Special Use Permit #2022-00028
1940 Duke Street
Carlyle Block C Rooftop Amendment

Application	General Data	
Project Name: Carlyle Block C Rooftop Amendment Location: 1940 Duke Street Applicant: I&G Direct Real Estate 25 LP	PC Hearing:	October 6, 2022
	CC Hearing:	October 15, 2022
	If approved, Expiration:	October 15, 2025
	Plan Acreage:	1.43 acres (62,198 SF)
	Zone:	CDD #1
	Proposed Use:	Office
	Gross Floor Area:	Existing Building: 219,986 GSF Proposed Rooftop: 2,900 GSF
	Small Area Plan:	Eisenhower East
	Green Building:	2019 Green Building Policy applies

Figure 2: Proposed Architecture

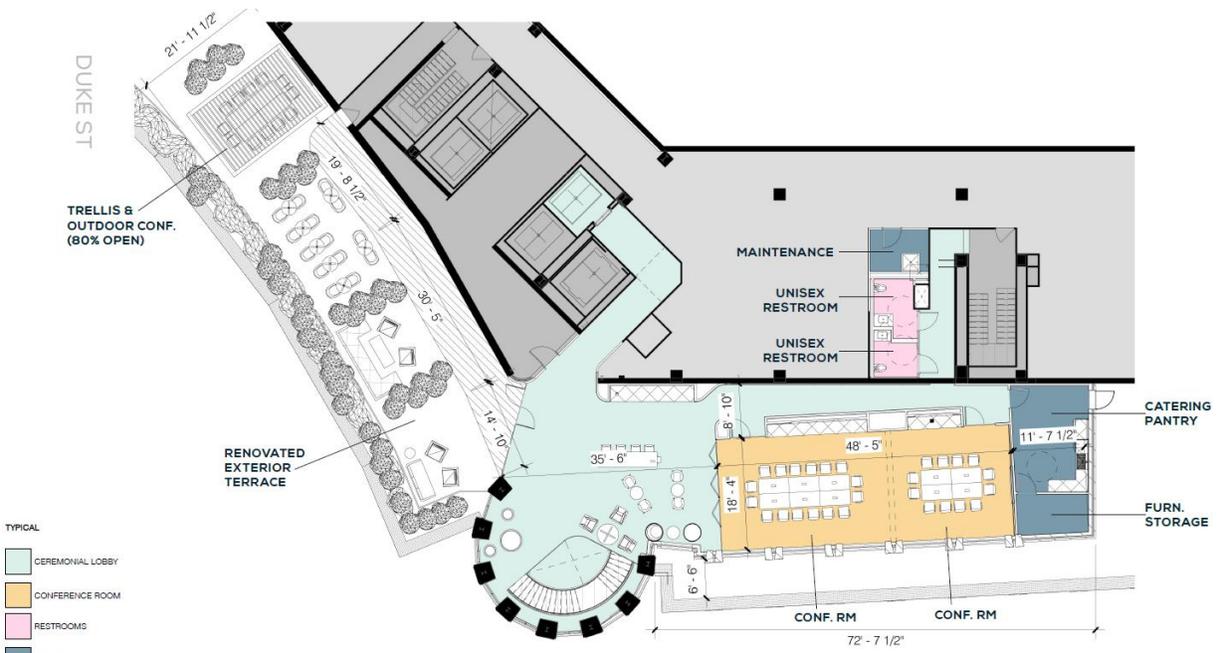
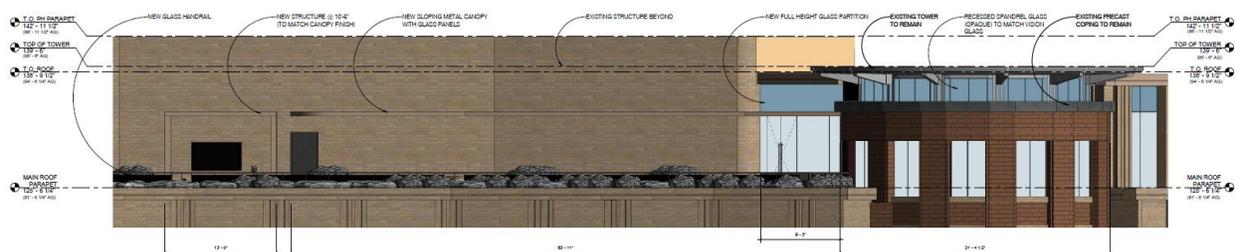
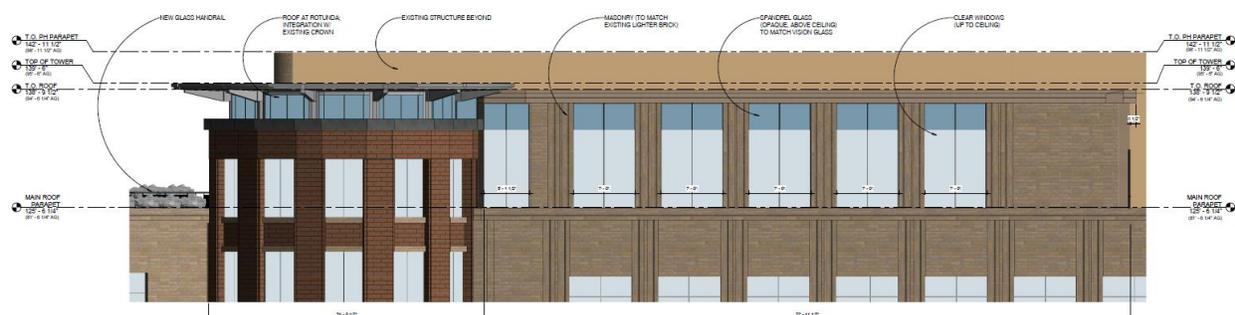
1. **Maintain Disengagement of Tower:** Maintaining the existing turret form, materials and visual separation was the highest priority of the DRB. The turret is a landmark architectural form with views from many surrounding areas of the City. It was also noted that DRB members did not feel the City's and Applicant's goals are necessarily in conflict regarding the tower; it is more about making some strategic design adjustments. Based on the revised plan, Board members agreed that keeping one additional column adjacent to the north roof terrace would create a stronger sense of the cylindrical form and should be studied.

3. **Vision glass in upper tower openings:** Depending on confirmation of additional details with the turret construction, the DRB's strong preference was for clear vision glass in the openings of the turret. Applicant's revised material shows this in some views, but spandrel glass in others, and continues not to show the significant, circumferential beam which connects the crown brackets. This in turn leaves the DRB with questions about the extent of demolition that is being proposed.

Figure 3/Attachment #7: Illustration of DRB Recommendation (with Planning Commission Recommended Amendment in red)

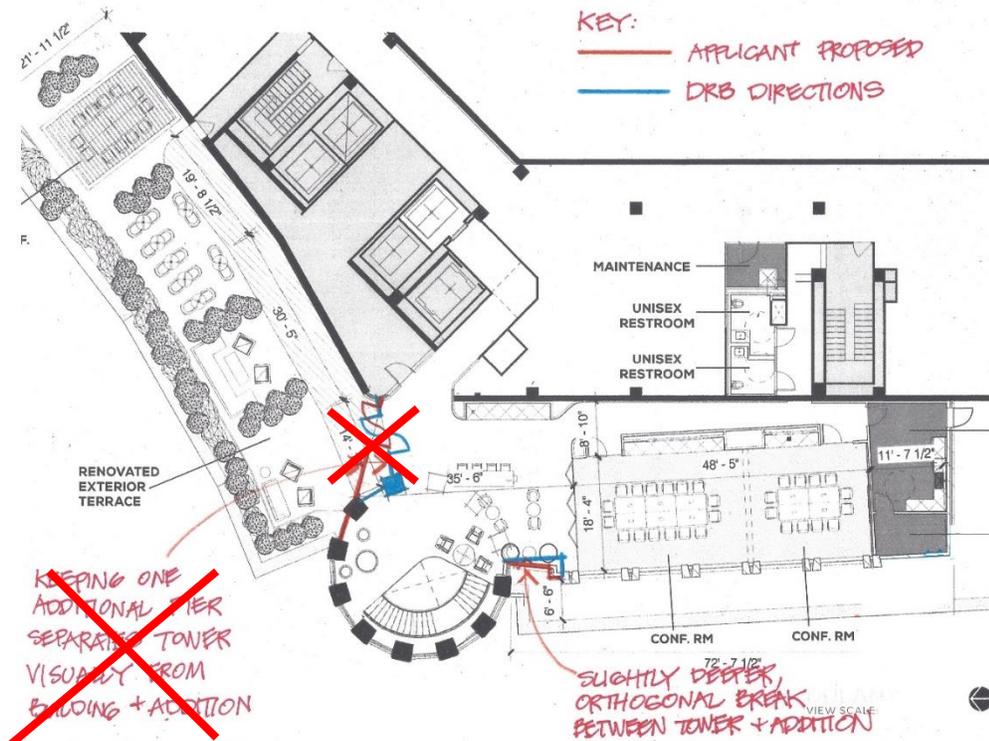
At the October 6, 2022 Planning Commission meeting, Planning Commission agreed with the applicant that retaining one additional column of the existing tower was not necessary for the architecture of the neighborhood and therefore made the following amendments to condition #70B,a in red.

Planning Commission Amended Condition 70B,a: To ensure the disengagement of the tower ~~along Duke Street from the proposed board room~~, ~~make the changes to the enclosure connection and~~ deepen the notch between the existing tower and the proposed board room as shown on Attachment #7. (P&Z)

Attachment 7: Diagram of Conditioned Architectural Changes

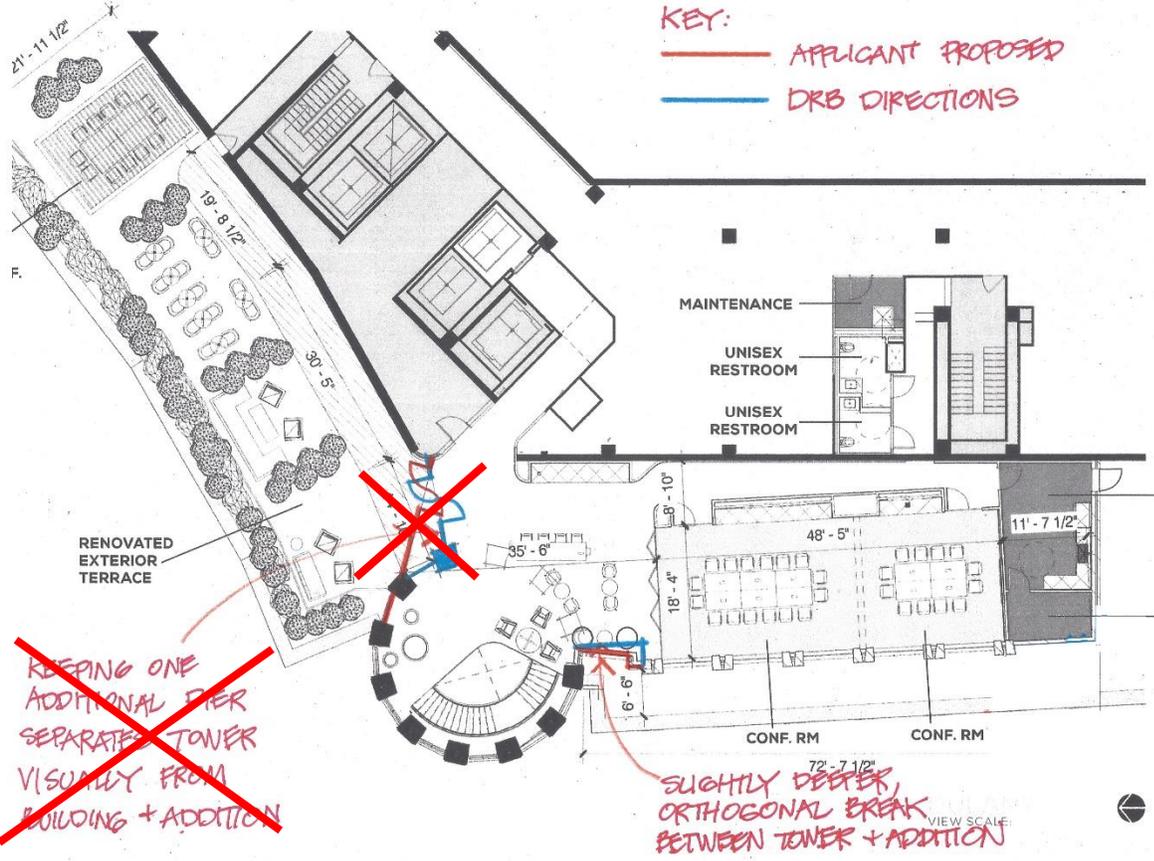
Planning Commission Amended Condition 70B,a: To ensure the disengagement of the tower ~~along Duke Street~~ **from the proposed board room**, ~~make the changes to the enclosure connection and~~ deepen the notch between the existing tower and the proposed board room as shown on Attachment #7. (P&Z)
